# Memorandum to the City of Markham Committee of Adjustment

February 27, 2024

**File:** A/209/23  
**Address:** 38 Autumn Glow Drive, Markham  
**Applicant:** Eric Hoh  
**Agent:** Donya Abasiliasi  
**Hearing Date:** Wednesday March 6, 2024

The following comments are provided on behalf of the East District Team. The Applicant is requesting relief from the following “Residential Two (R2\*190\*192\*304\*306)” zone requirements of By-law 177-96, as amended, as it relates to two adjoining covered patios, one extending from the existing garage and one extending from the existing dwelling. The variance requested is to permit:

Drawing Title PROPOSED COVER PATIO PLAN

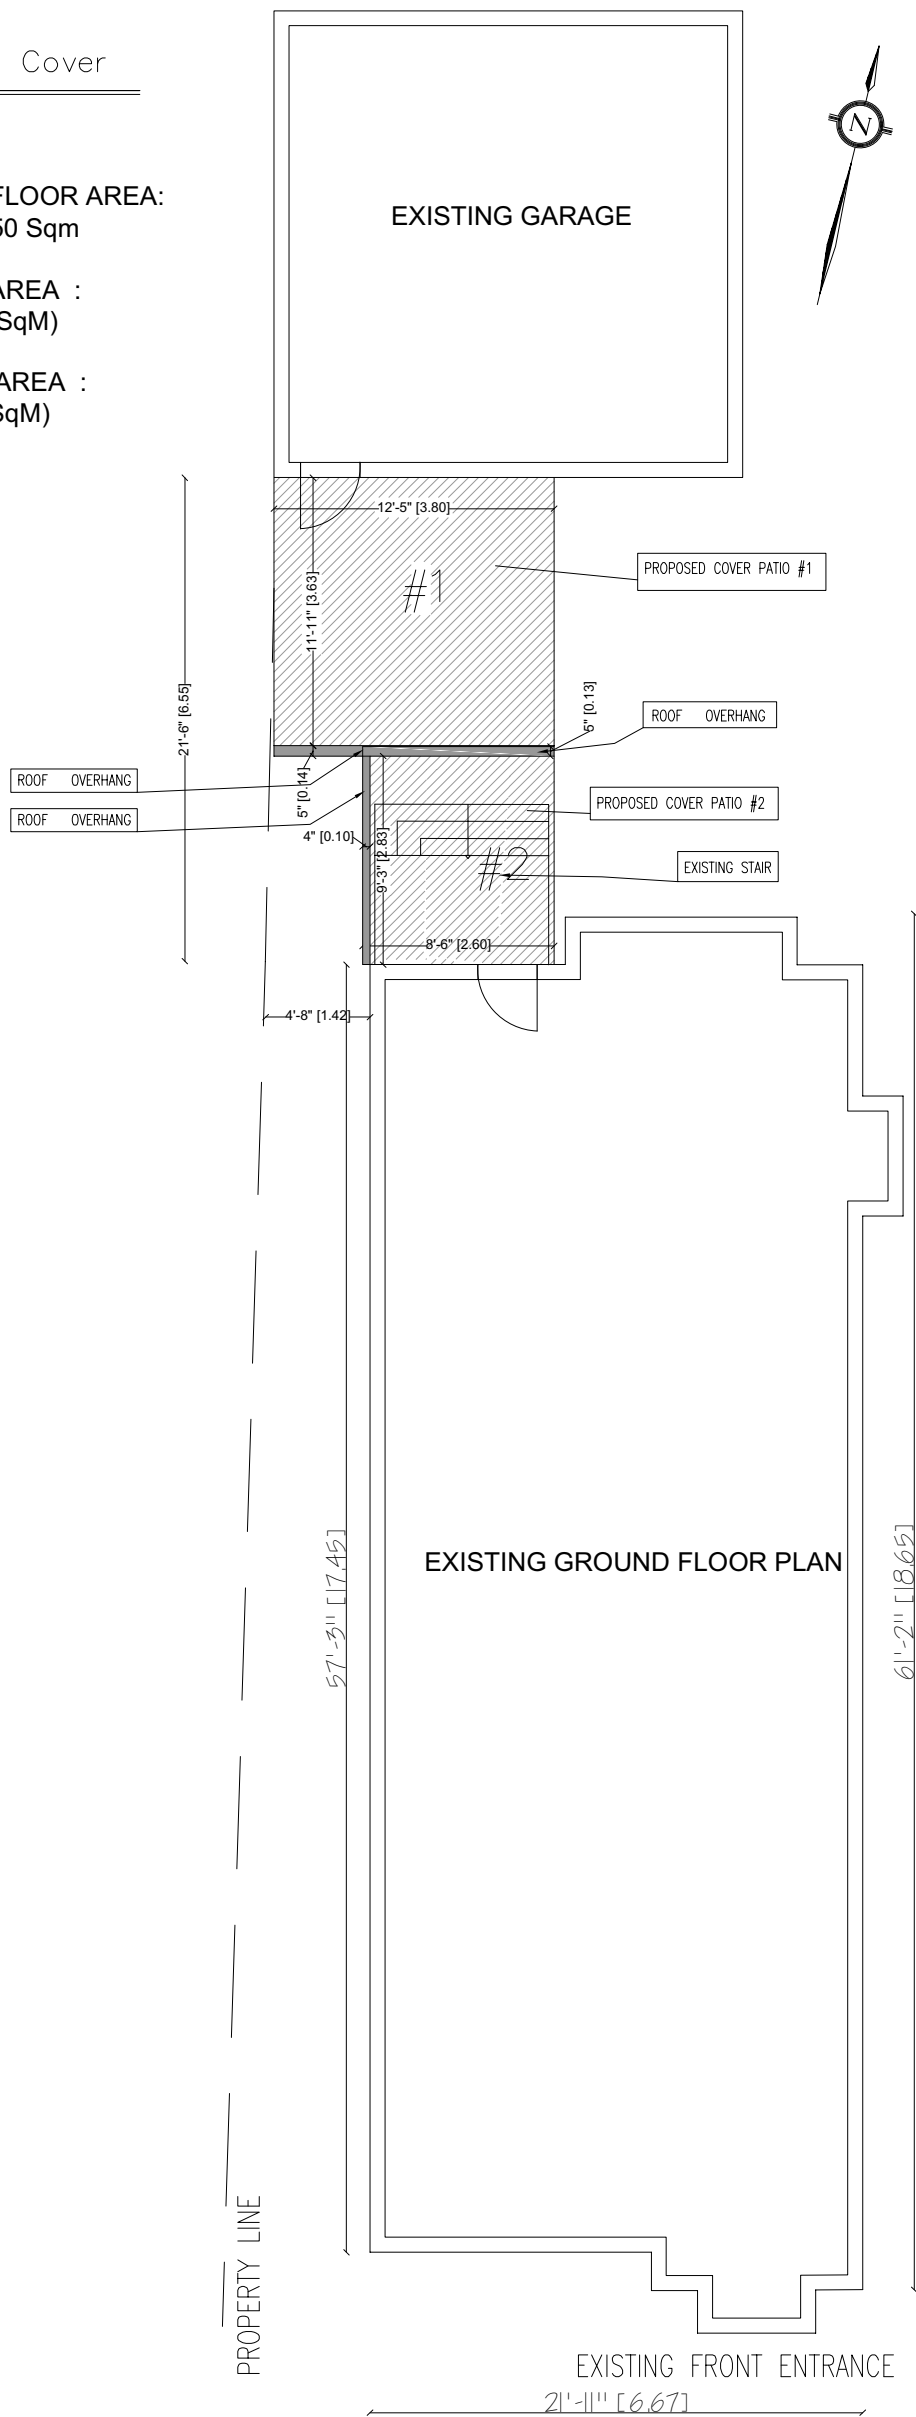
a rear yard setback of 0.64 metres, whereas the by-law requires a minimum rear yard setback of 5.8 metres;

Staff’s previous comments dated January 11, 2024 (refer to Appendix ‘C’). The requested variance would result in a built form that is not in keeping with the character of the neighbourhood and therefore does not meet the general intent of the zoning by-law. Staff are of the opinion that the requested variance does not meet the four tests of the Planning act and do not support the approval of the application.

Planning Staff have reviewed the application with respect to Section 45(1) of the *Planning Act*, R.S.O. 1990, c. P.13, as amended, and are of the opinion that the requested variance does not meet the four tests of the *Planning Act* and recommend the application be denied. Staff recommend that the Committee consider public input in reaching a decision.

Drawing Title PROPOSED COVER PATIO PLAN

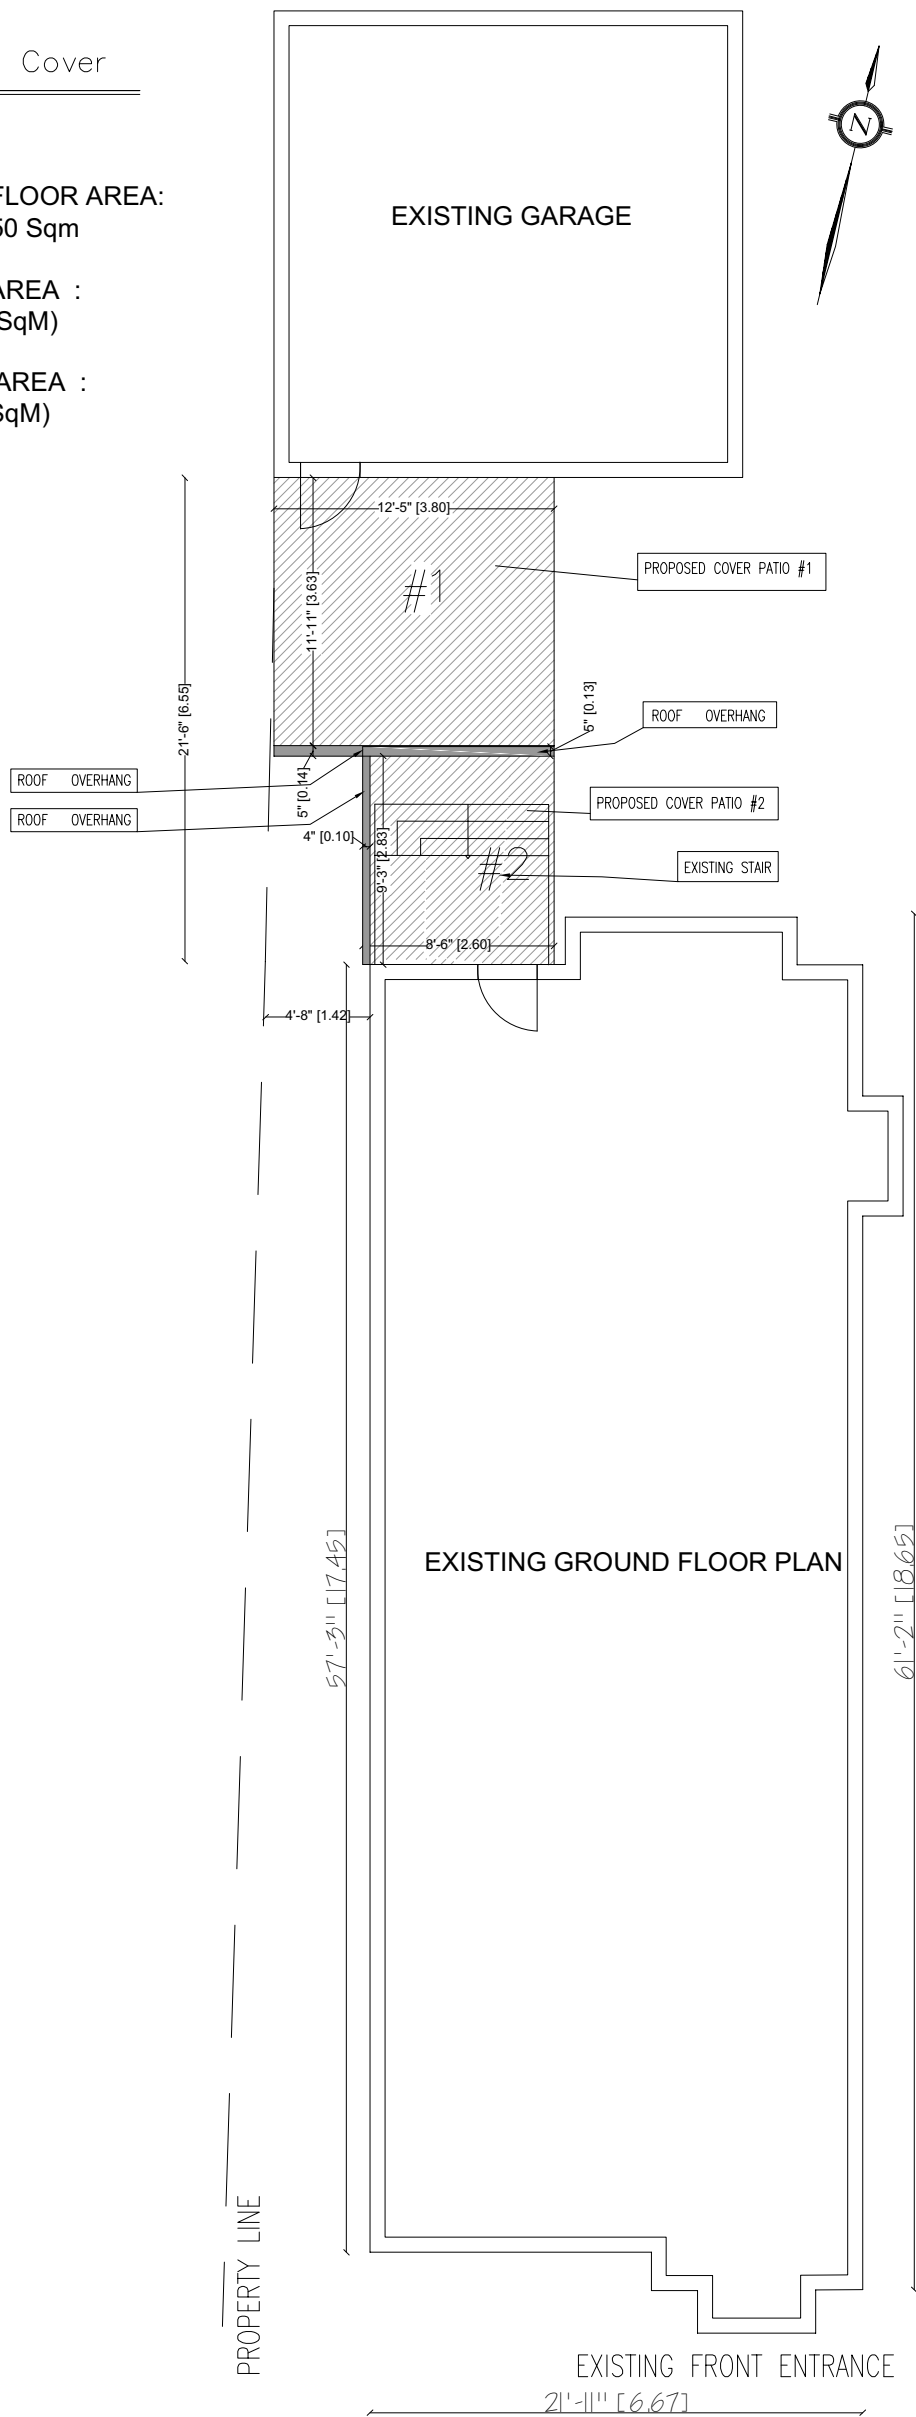
The Applicant is requesting relief to permit a minimum rear yard setback of 2.10 feet (0.64 metres), whereas the By-law requires a minimum rear yard setback of 19.03 feet (5.80 metres). This represents a reduction of approximately 16.93 feet (5.16 metres). The variance is entirely attributable to the rear covered porch and existing garage (which extends to 36 Autumn Glow Drive).

Staff consider the requested variance to be substantial with a rear yard setback reduction of approximately 16.93 feet (5.16 metres) and that the variance is not minor in nature. Staff’s opinion on the proposed development is that it does not meet the existing character of the neighbourhood. The neighbourhood was designed with the intent to have rear garages detached from the main dwelling. In addition, the outdoor amenity space will be reduced. This variance is undesirable as it would be the first of this nature and is not in keeping with the character of the neighbourhood.

The proposed development does meet the general intent and purpose of the Official Plan, where Residential Low Rise neighbourhoods are to experience minimal changes in the future. The proposal consists of two covered porches connecting the existing dwelling and the existing rear garage which represents a substantial change in the

Staff are not in support of the proposed covered porches, and are of the opinion that the requested variance does not meet the four tests for Minor Variance under the Planning Act.
